ADDENDUM NO. 3

March 4, 2011
09076.D

to the construction documents
Beacon Hill Linear Park Phase One
CIMS Project No. 2600572

C 5.2

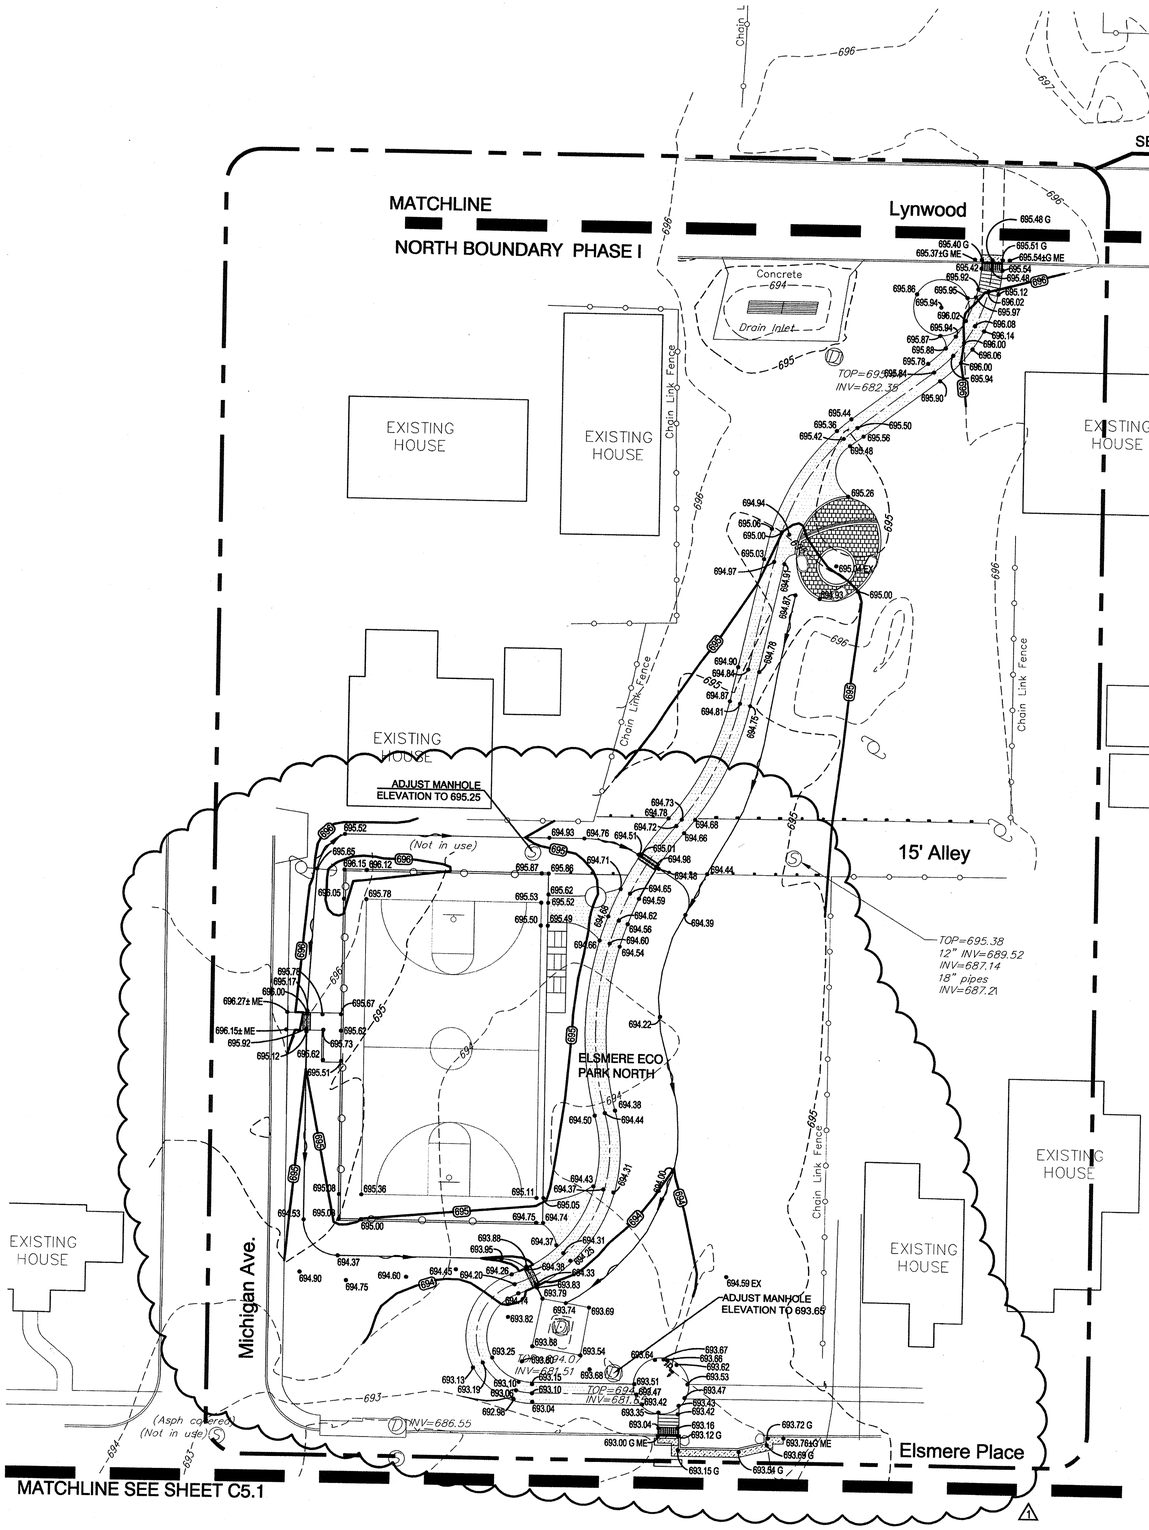
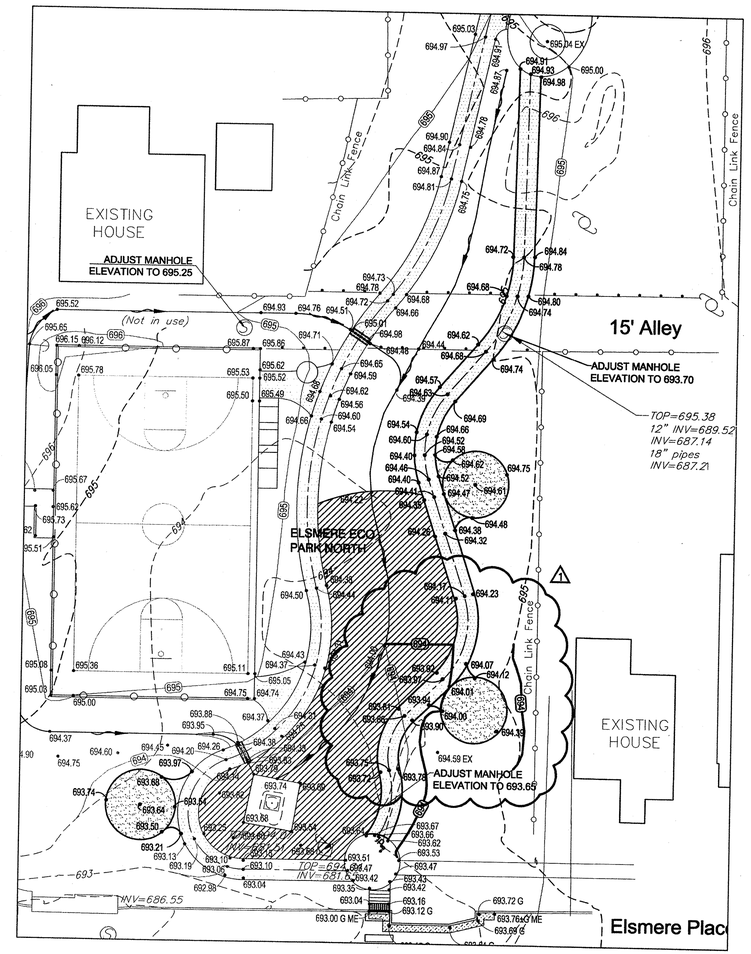
1 REVISION:
REVISED CONTOURS AND SPOT ELEVATIONS PER SITE CHANGES. ADDED SWALE AROUND COURT.

ADDENDUM NO. 3 ATTACHMENT "P"

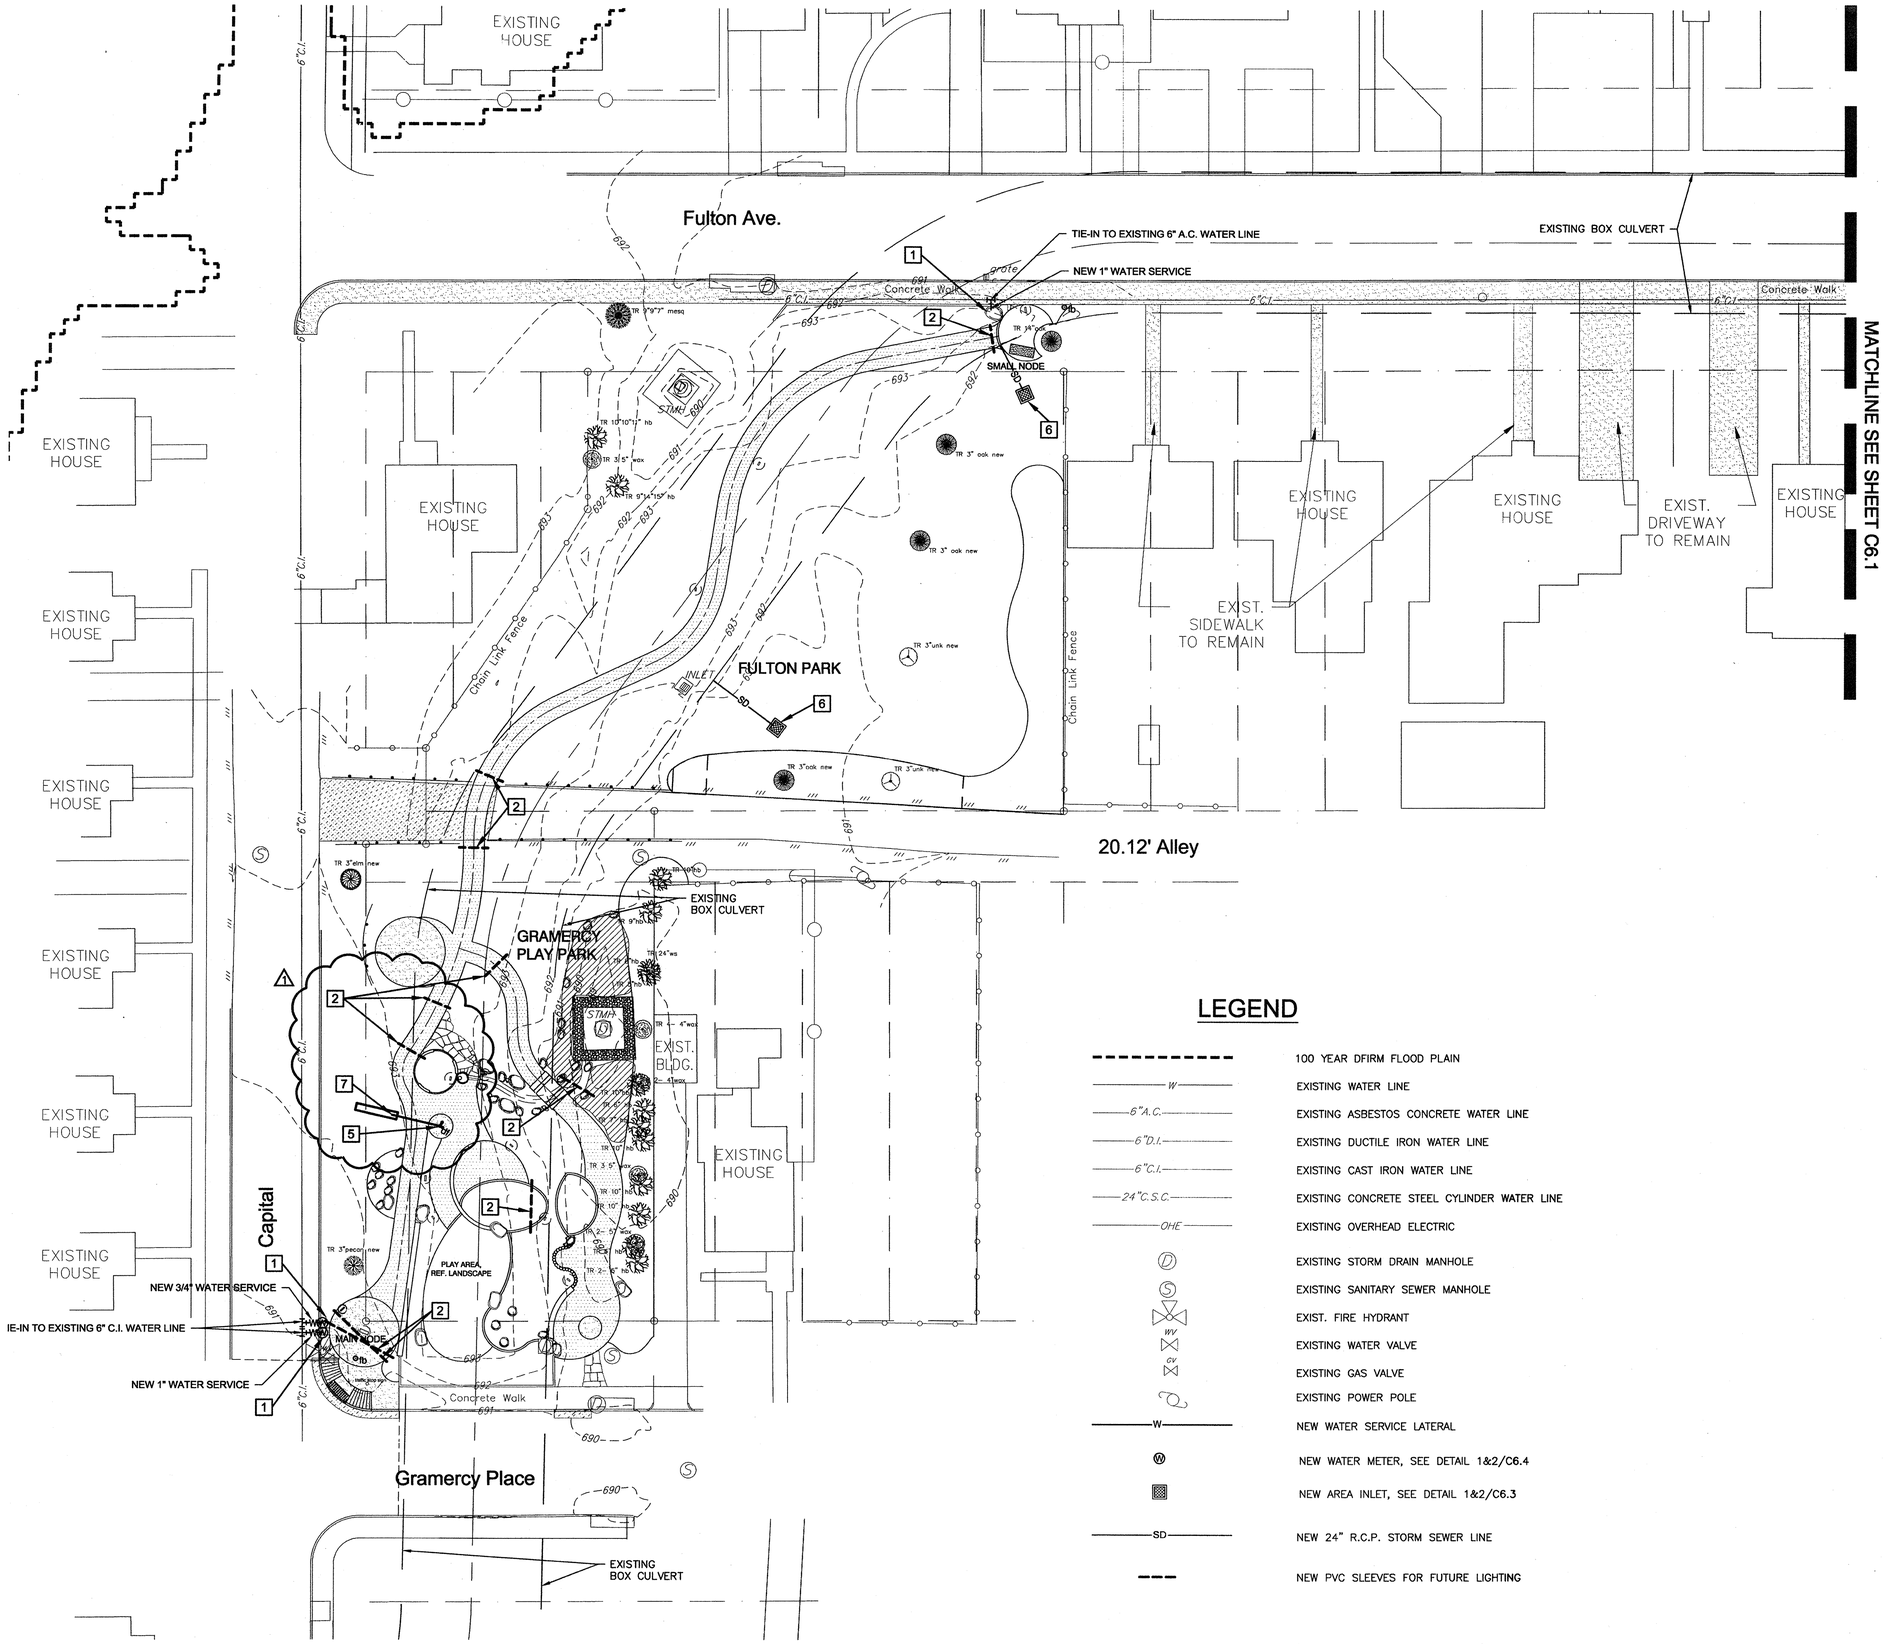
1 REVISION:
REVISED SLEEVES AND DRAIN LINE LOCATION.
REVISED DETAIL REF. IN KEYNOTE 5.

C 6.1

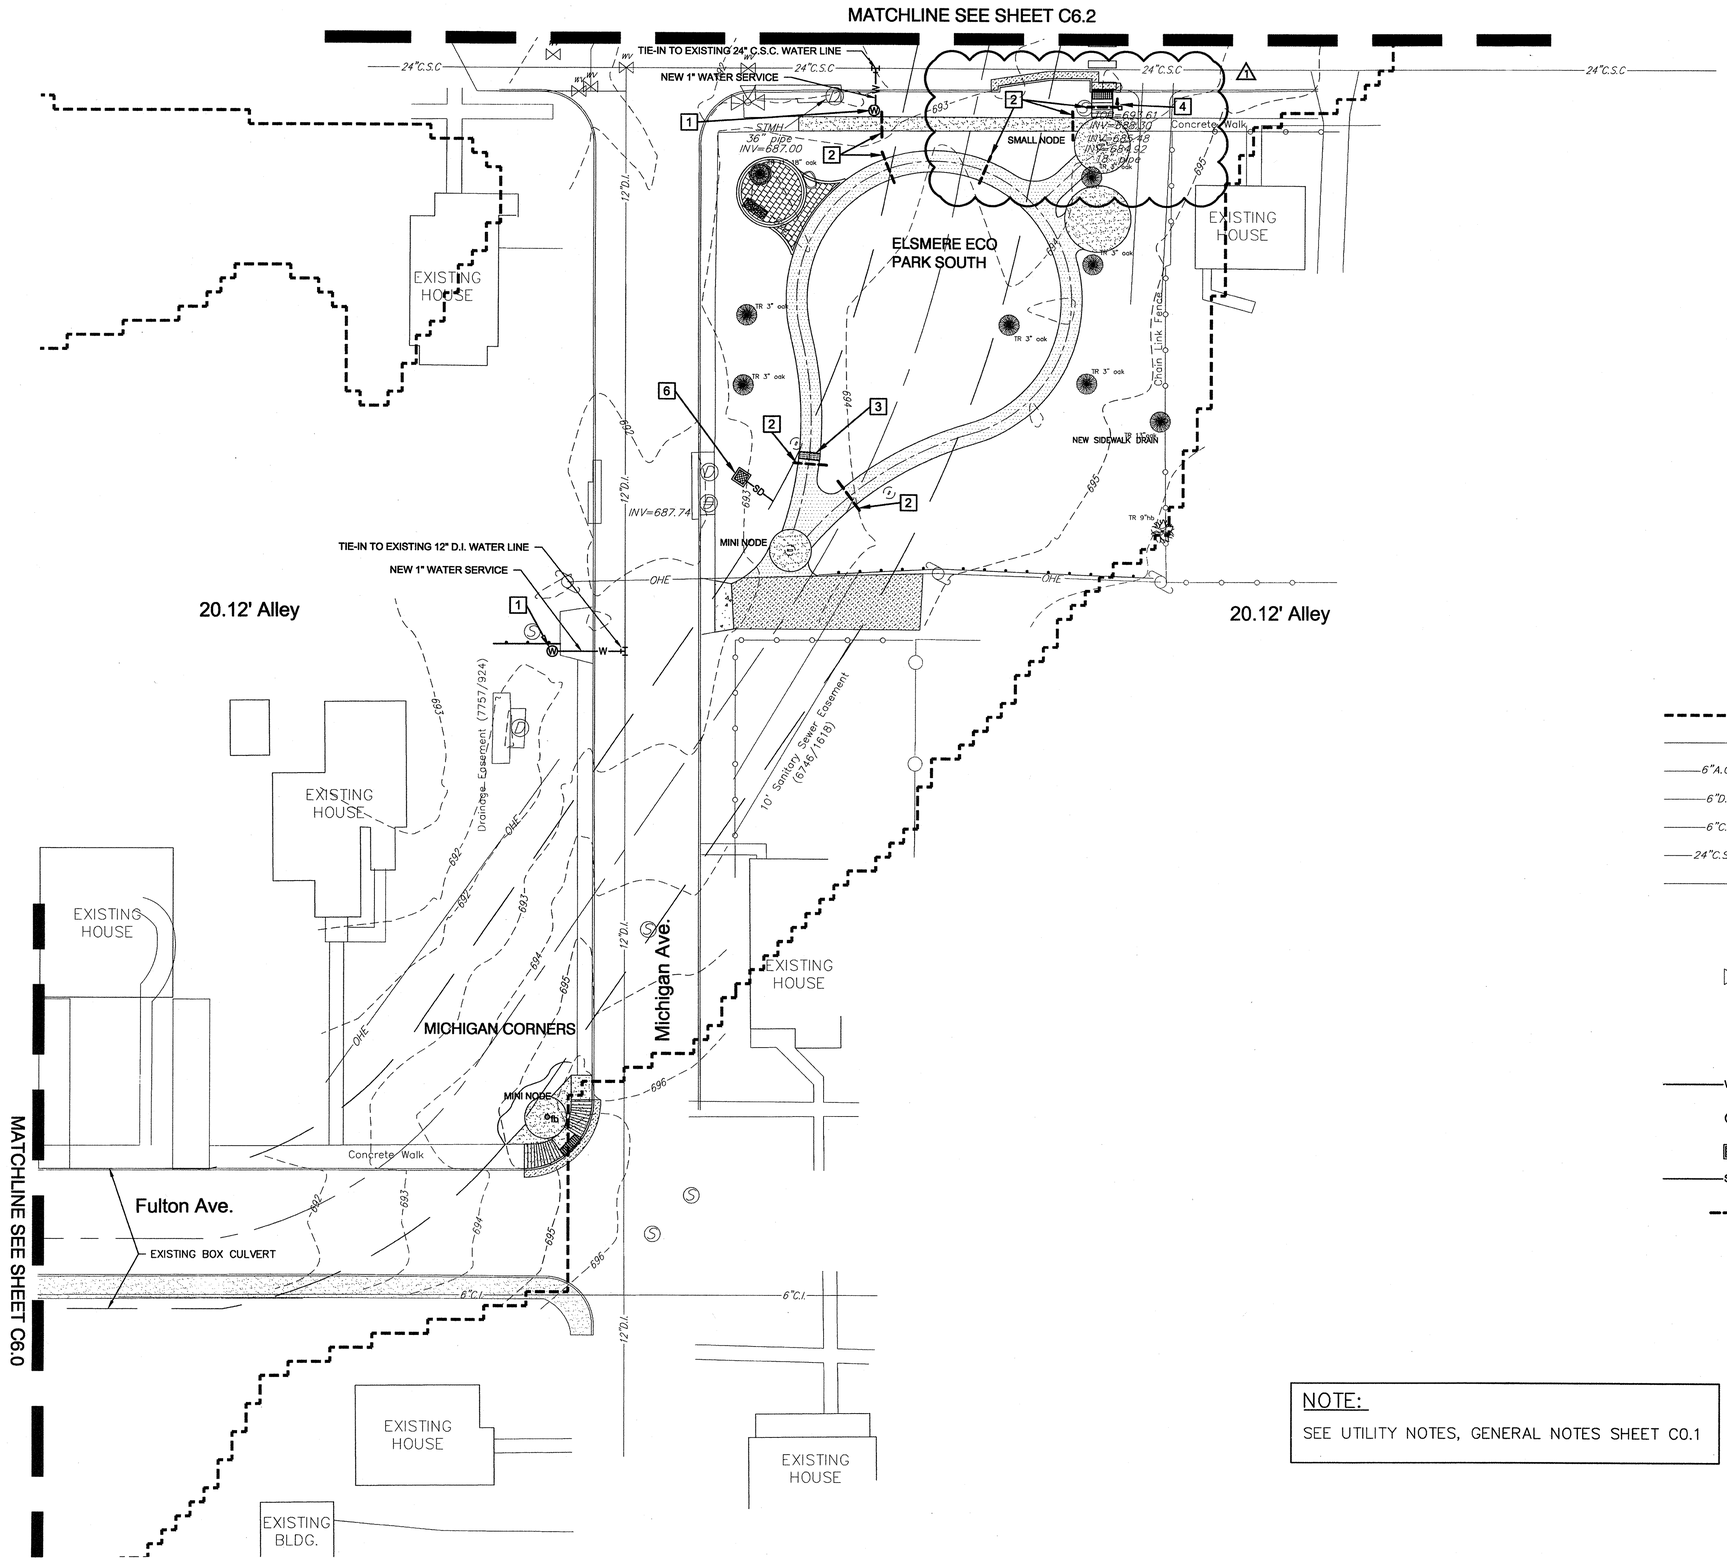
REVISION: (1)
REVISED LOCATION OF SLEEVES AND LIGHT POLE, REVISED DETAIL REF. IN KEYNOTE 5.

ALTERNATE UTILITY PLAN
SCALE 1" = 20'

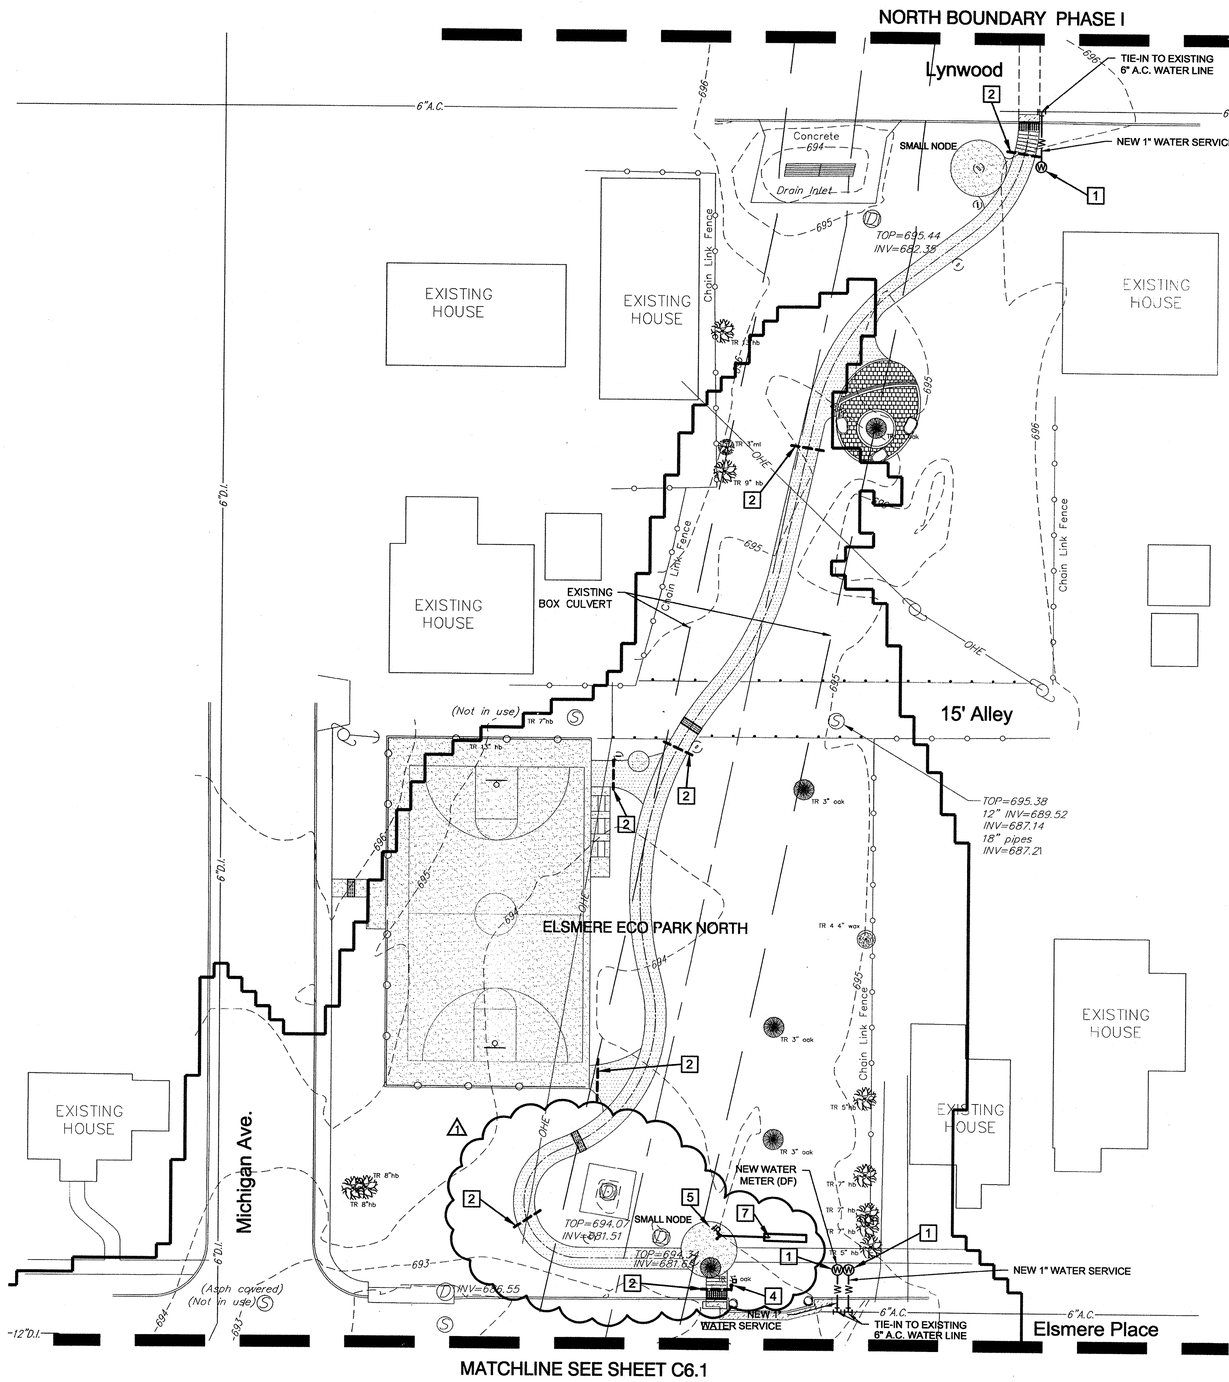
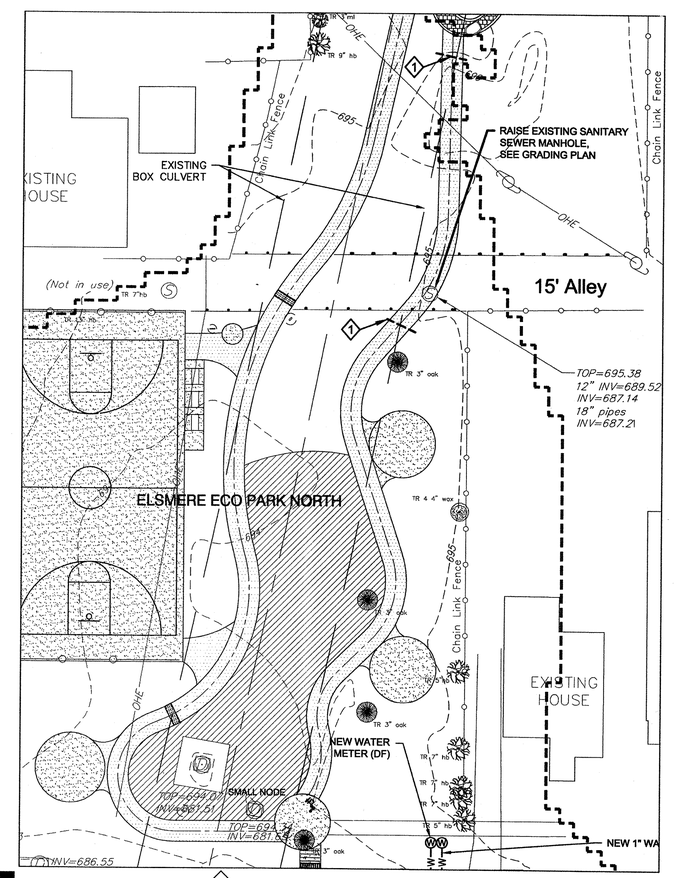
△1 **REVISION:**
REVISED LOCATION OF SLEEVES, LIGHT POLE AND ADDED SIDEWALK DRAIN. REVISED DETAIL REF. IN KEYNOTE 5.
